Hi-Performance MerCruiser Tailpipe Change

1999 Model Year Hi-Performance 500 C and 500 Bulldog Engine Packages.

- a** - Standard Exhaust Pipe, 1998 & Below
- b** - Standard Exhaust Pipe 1999 & Above

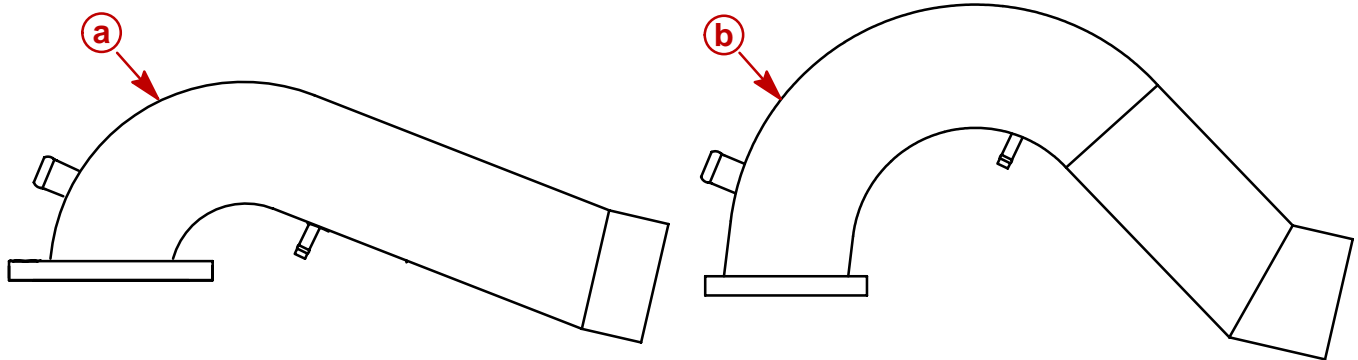
Tailpipes on models listed above will have a higher rise built into the pipe but will exit the transom in the same location as previous tailpipes on Gil/MerCruiser exhausts. Hatch clearance should not be a problem since the top of the pipes do not extend above the flame arrester.

Although the extra pipe rise should help prevent water ingestion/reversion on installations that are marginal in water line to tailpipe height, it is still the responsibility of the installer to test for water ingestion problems. Internal exhaust shutters and external flappers are also required on all Hi-Performance exhaust installations.
